Review of ERCOT Premise Forecast

Itron, Inc.
Forecasting and Load Research Solutions
11236 El Camino Real
San Diego, CA 92130-2650

January 10, 2014

ERCOT Premise Forecast Evaluation

Figure 1: ERCOT Premise Growth Rates

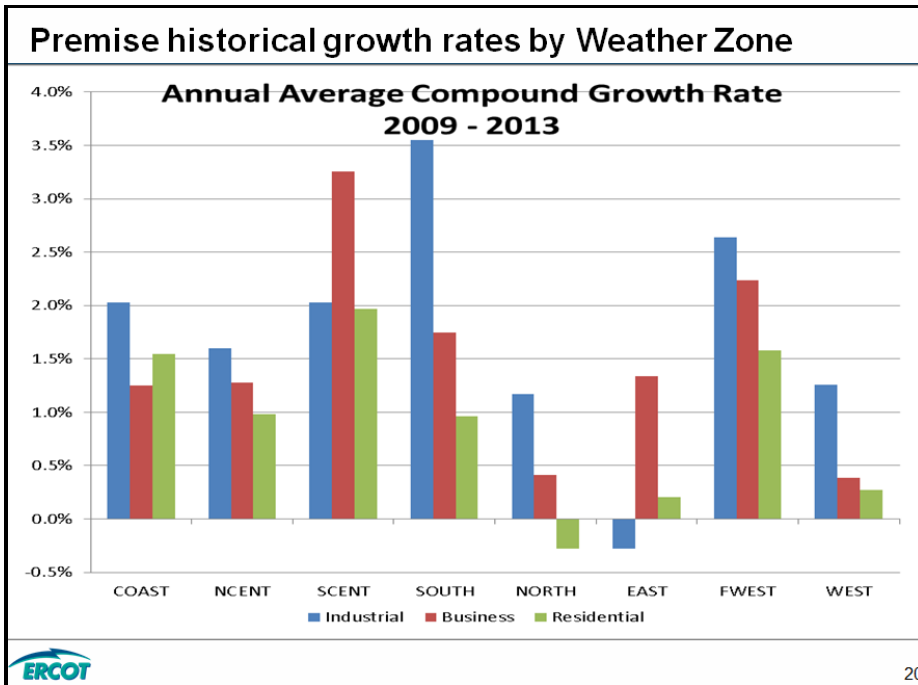
The main growth driver in the ERCOT framework is a growth index developed from the residential, business, and industrial premise forecast. The premise forecast is created by calculating the historic five year annual average compound growth rate and applying the growth rate through the forecast horizon. These growth rates, shown in Figure 1, are based on ERCOT's December 10, 2013 presentation.

Figure 4: Residential Scenario Results

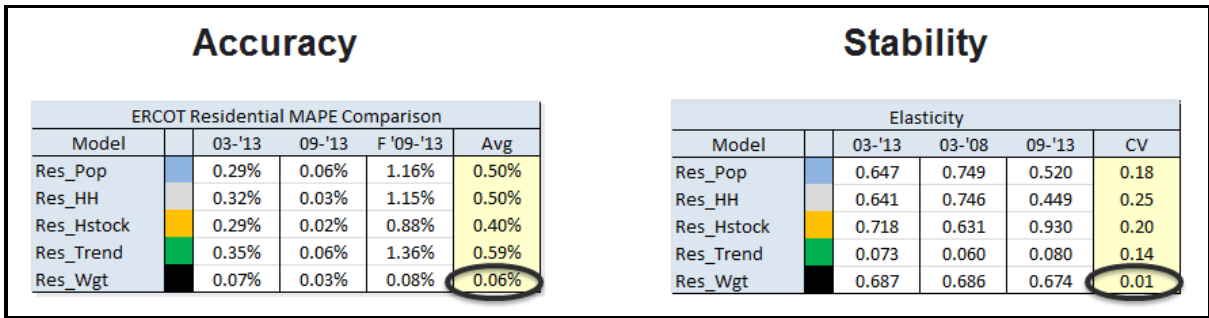
The results of the scenarios are shown in Figure 4 with the scenarios listed across the top and the models listed on the left axis. The strongest model is the weighted index (Res_Wgt) as indicated by the lowest MAPE and CV values. This model is an improvement over the five year average (Res_Trend model).

1. **Residential Economic Index.** The weighted index models demonstrate a strong improvement over the Time Trend (five year average) in model accuracy and stability at both the ERCOT-level and Regional Level. Itron recommends that ERCOT implement a weighted index approach as the base approach to Residential Premise forecast. The index should be comprised of Housing Stock and Population and use equal weights.
2. **Low Growth Zones.** Forecasting premises with low growth using a statistical model presents difficulties in obtaining significance. For Zones with 2004-2012 Compound Annual Growth rate less than 1.0% (West and North), Itron recommends that ERCOT continue to use the five year growth rate method.

Figure 5: Residential Premise Index Model Fit

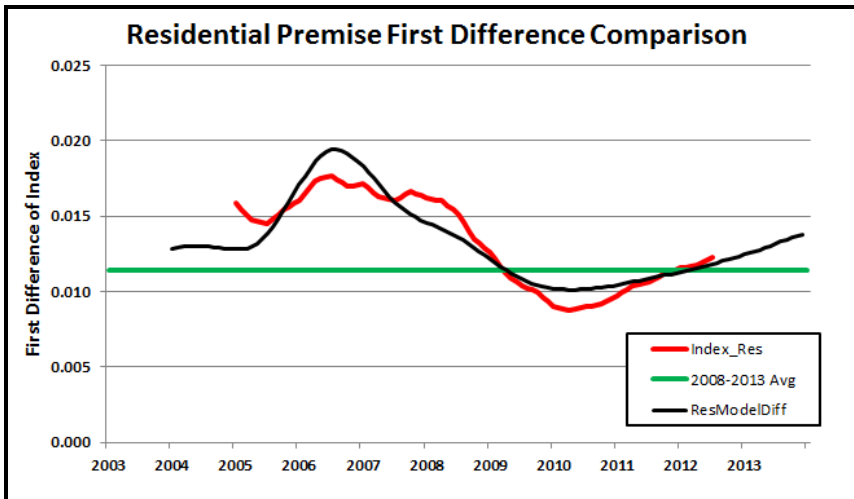
The overall model fit is best seen in Figure 5. This figure shows the weighted index model (Index_Res) and the five year average against the historical premise counts as annual differences.

Figure 6: Residential Premise Index Forecast Results

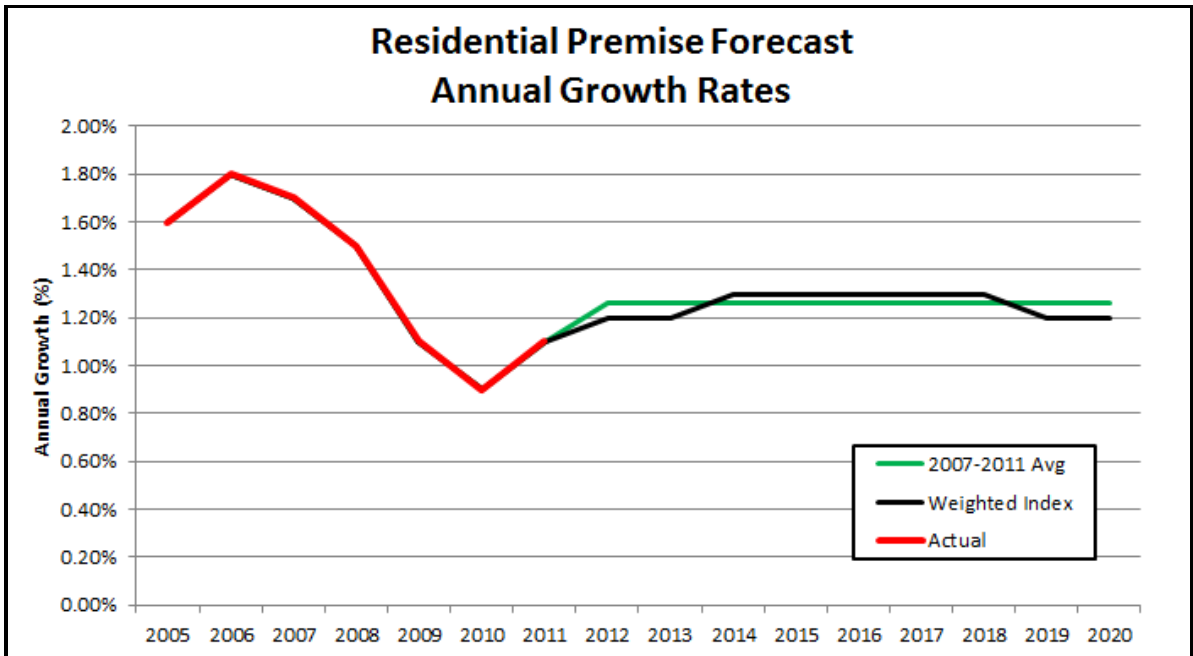
The forecasted growth rate of the weighted index model compared to the five year average is shown in Figure 6. While the results are similar, the weighted index model shows slight variations in the forecast due to the changes in the population and housing stock forecasts.

Figure 10: Business Premise Index Model Fit

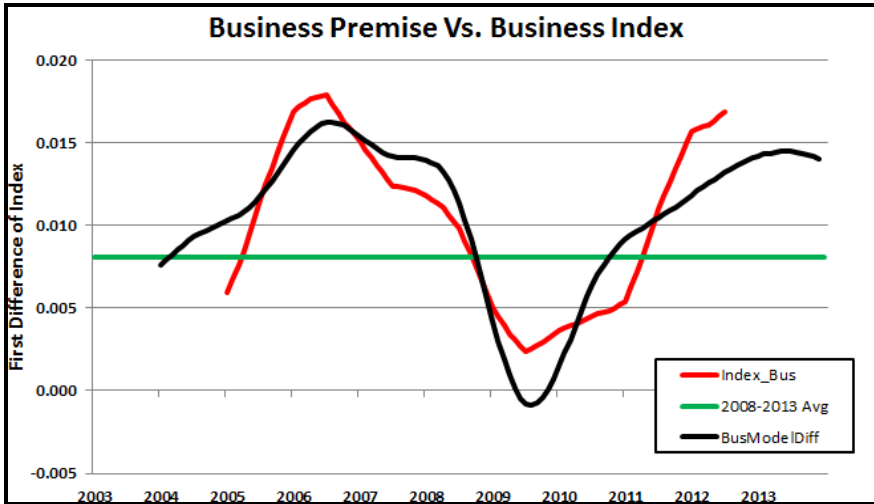
The overall model fit is seen in Figure 10. This figure shows the weighted index model (Index_Bus) and the five year average against the historical premise counts as annual differences.

Figure 11: Business Premise Index Forecast Results

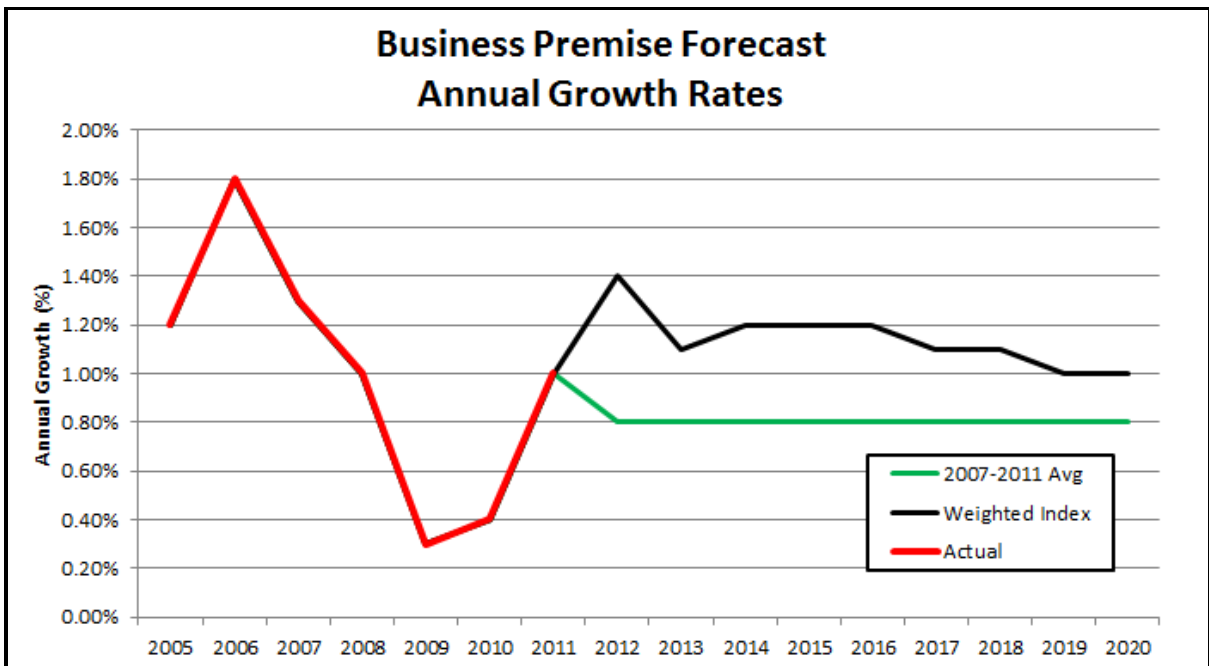
The forecasted growth rate of the weighted index model compared to the five year average is shown in Figure 11. While the results are similar, the weighted index model shows higher forecast due to the anticipated growth in non-farm employment, population and housing stock.

1. **Business Economic Index.** The weighted index models demonstrate a strong improvement over the Time Trend (five year average) in terms of both model accuracy and stability at both the ERCOT-level and Regional Level. Itron recommends that ERCOT implement a weighted index approach as the base approach to Business Premise forecast. The index should be comprised of Non-Farm Employment, Housing Stock and Population and use equal weights.
2. **Far West Zone.** Unlike the other zones, the Far West zone does not show forecast improvement when using the weighted index compared to the five year average method. This result implies that the Far West Zone has been growing linearly and is not as subject to economic variations as the other zones. Itron recommends that ERCOT continue to use the five year average for this zone.

Figure 12: Industrial Economic Drivers

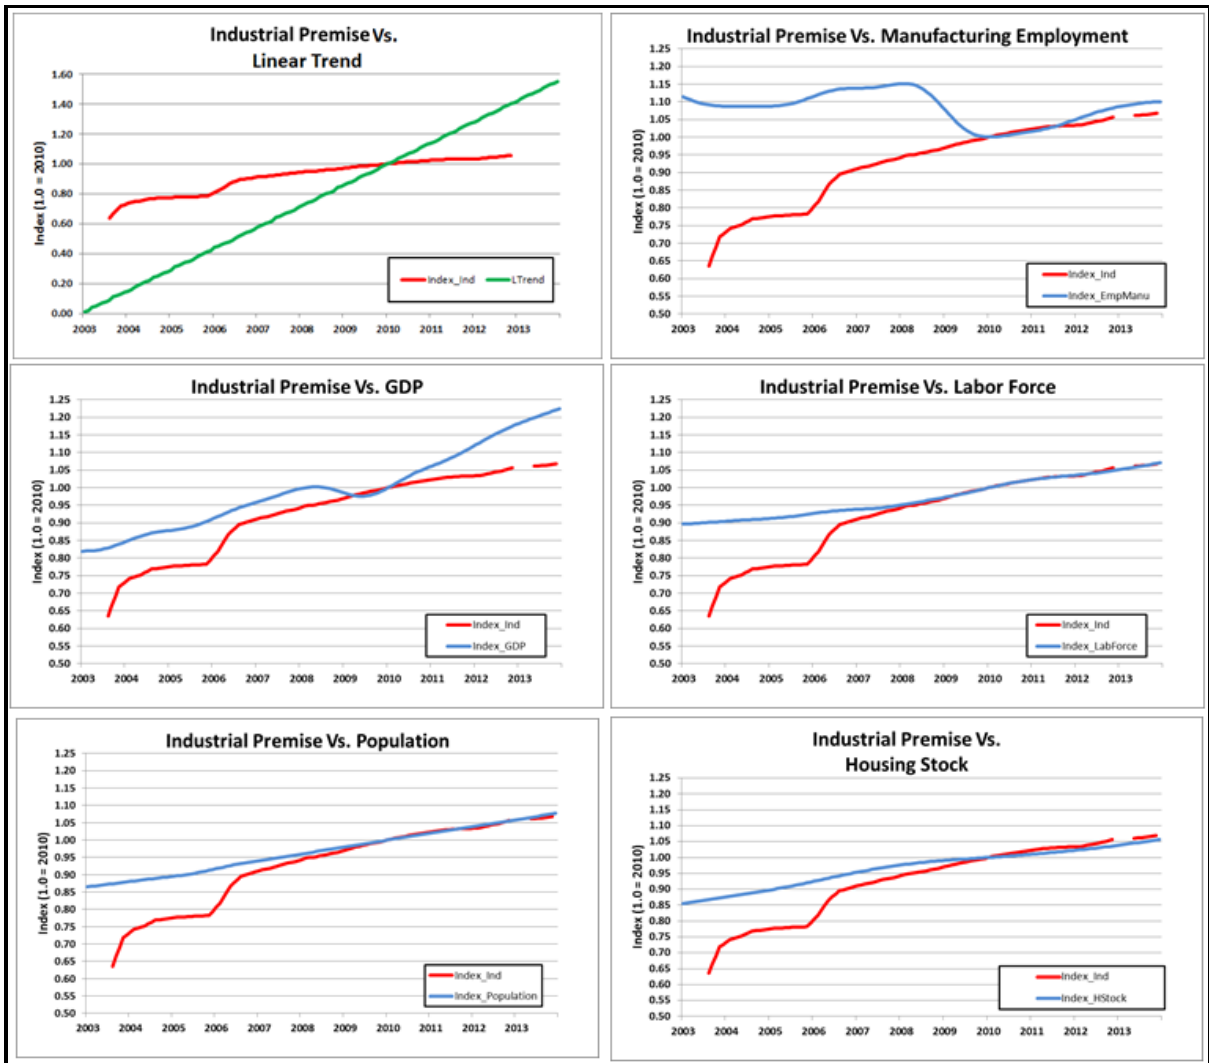
The primary issue in the historic industrial premise counts shown in Figure 12 is the dramatic premise increase in 2006. ERCOT explained the increase as a result of class definitional changes.

To resolve the 2006 data issue, the test scenarios were modified around the data shift. The scenarios are defined below.
